TO: Dr. Jesse Bacon, Superintendent
FROM: Danny Clemens, Director of Facilities
Date: November 15, 2023
RE: Change Order #03 – BMS Window and Storefront Trim **DC**

PROJECT: *(Name and address)*
Bernheim Middle School Renovation
700 Audubon Drive, Shepherdsville, KY
40165

CHANGE ORDER INFORMATION:
Change Order Number: 003
Date: November 27, 2023

PROJECT:	Bernheim Middle School Renovation Shepherdsville, KY	REQUEST FOR PROPOSAL NO.:	05
OWNER:	Bullitt County Public Schools 1040 Highway 44 East Shepherdsville, KY 40165	DATE:	19-Oct-2023
TO CONTRACTOR:	Calhoun Construction Services, Inc. 7707 National Turnpike Louisville, KY 40218	ARCHITECT:	Studio Kremer Architects 1231 S Shelby Street Louisville, KY 40203
		ARCHITECT'S PROJECT NO.:	2022-36 BG# 23-051

project no.:	2022-38	sketch no.:	
drawn by:	10/19/2023	reference no.:	RFP-5.1
checked by:	CVA		
scale:	3/8" = 1'-0"

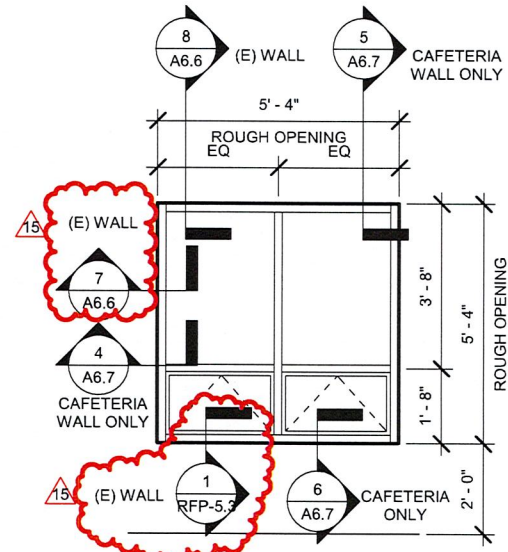
- Item 1:** REFERENCE RFP-5.1, 5.2, and 5.3 DRAWING
- Modified Window Type A and E's window jamb along the existing brick veneer wall to include break metal that matches the window frame color.
 - Modified Window Type E to provide a new brick sill.

RFP-5.3

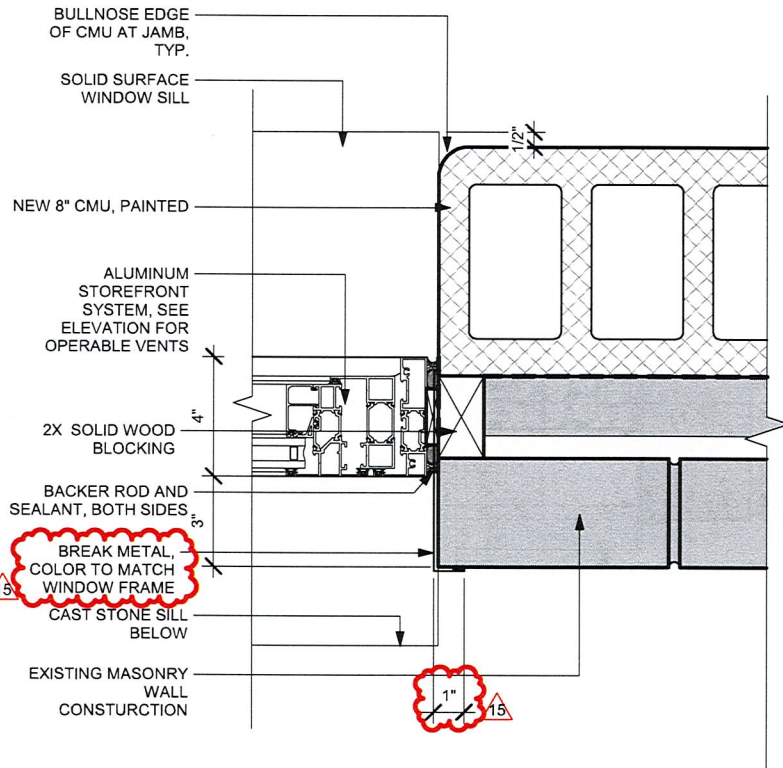
① ALUMINUM WINDOW SILL @ NEW BRICK SILL- RFP-5
3" = 1'-0"

RFP-5.2

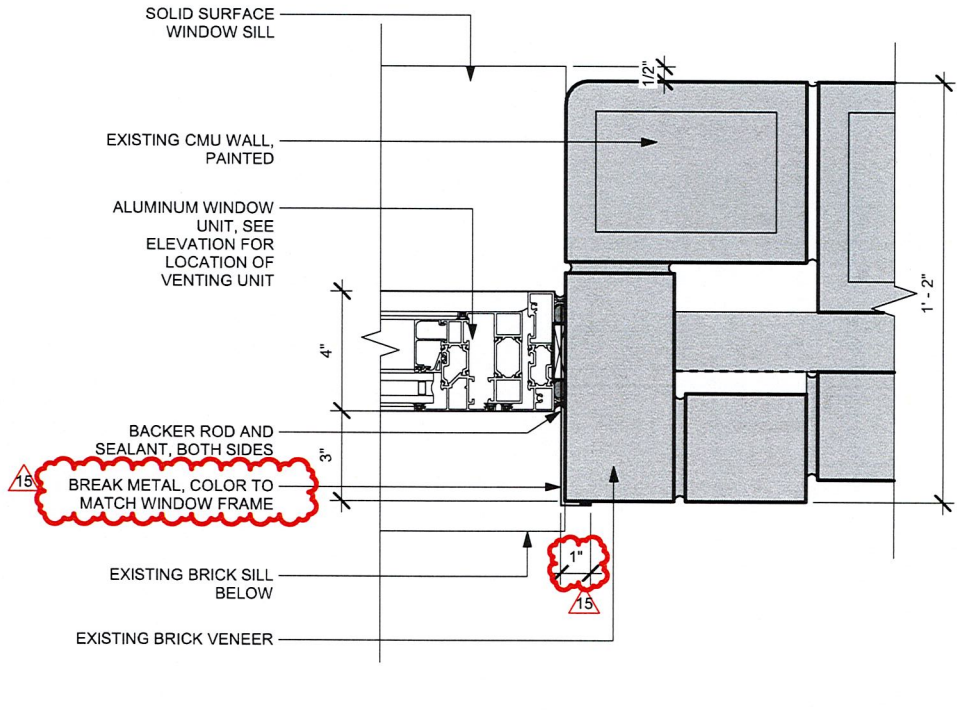
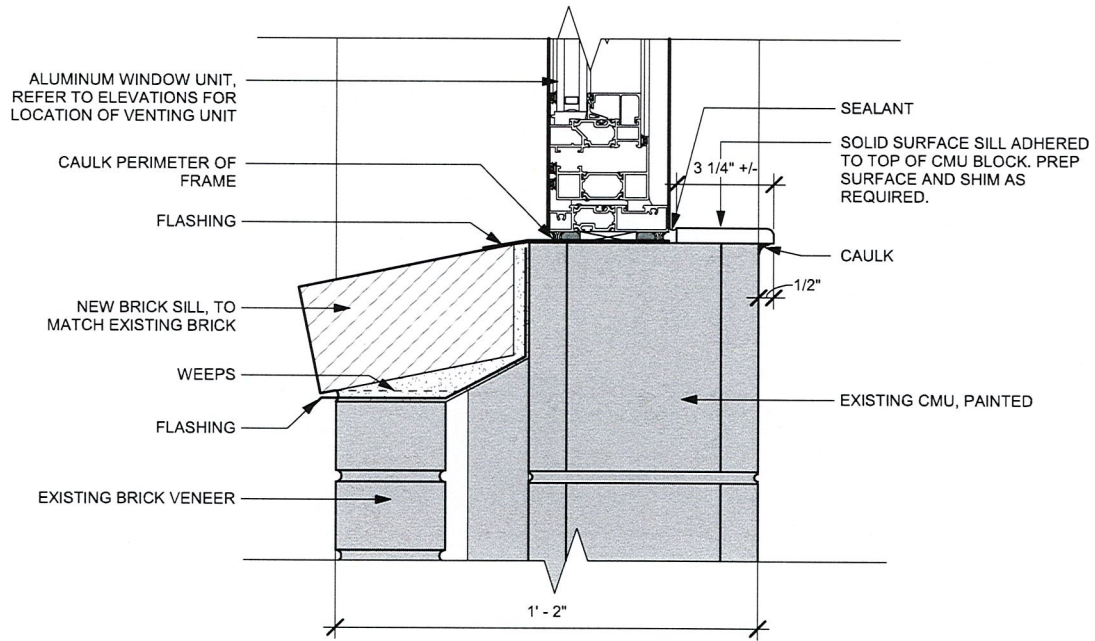
② ALUMINUM WINDOW JAMB @ EXISTING WALL - RFP-5
3" = 1'-0"

RFP-6

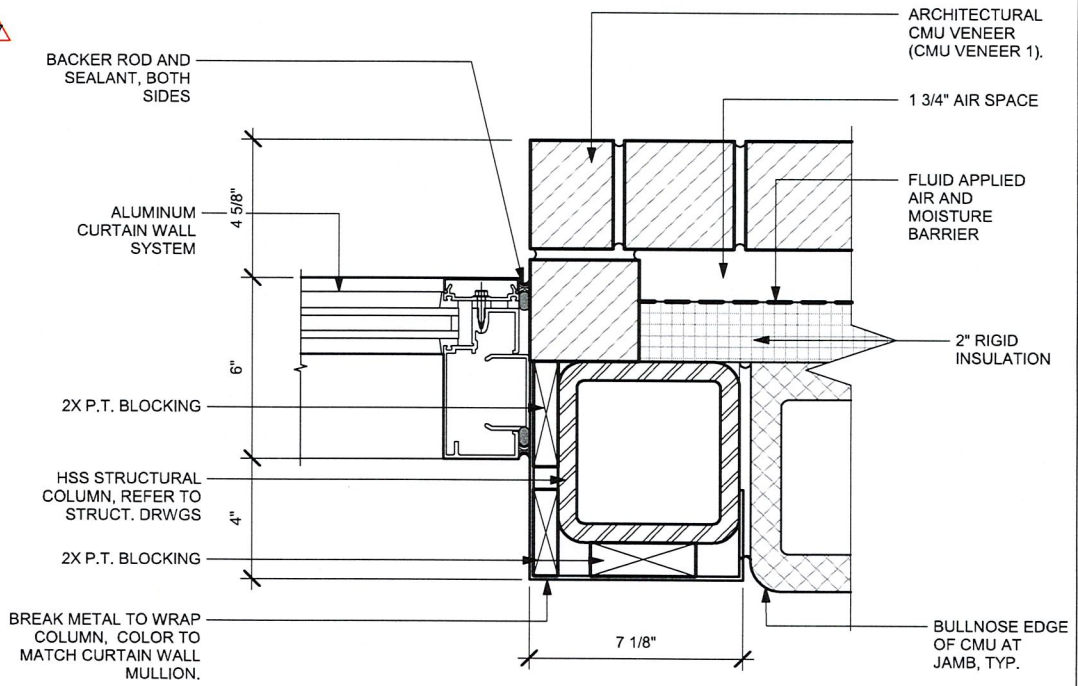
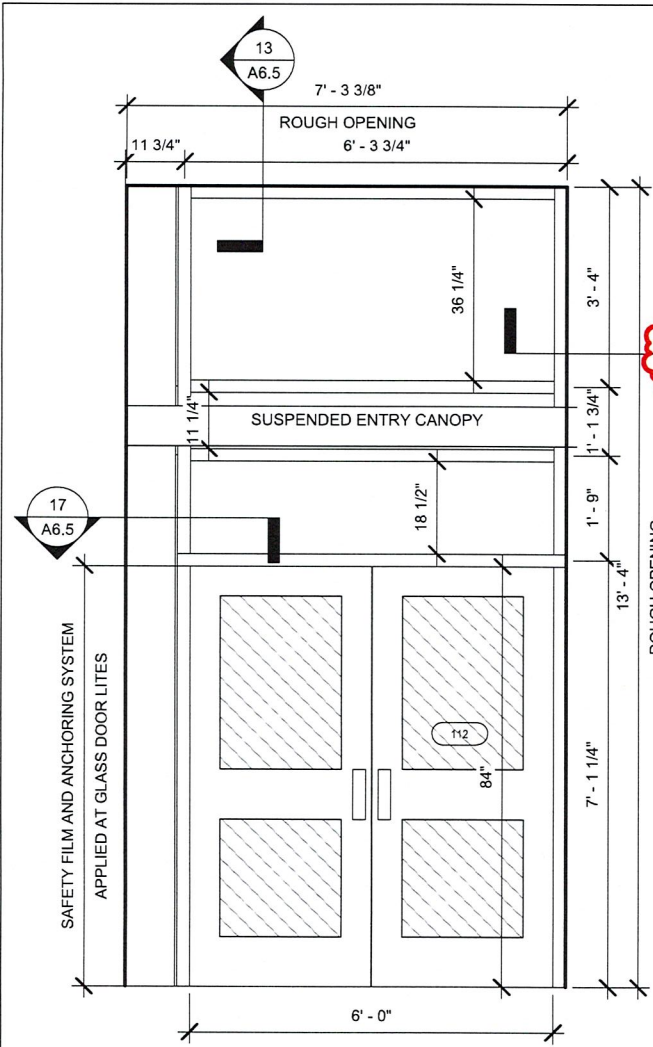
Please provide pricing for the attached RFP-6 that is in direct response to RFI-31 regarding the jamb condition at C2.

- Modified Curtain Wall C2 jamb detail to include break metal to wrap column. The interior CMU back up wall shall stop on outside face of structural column.
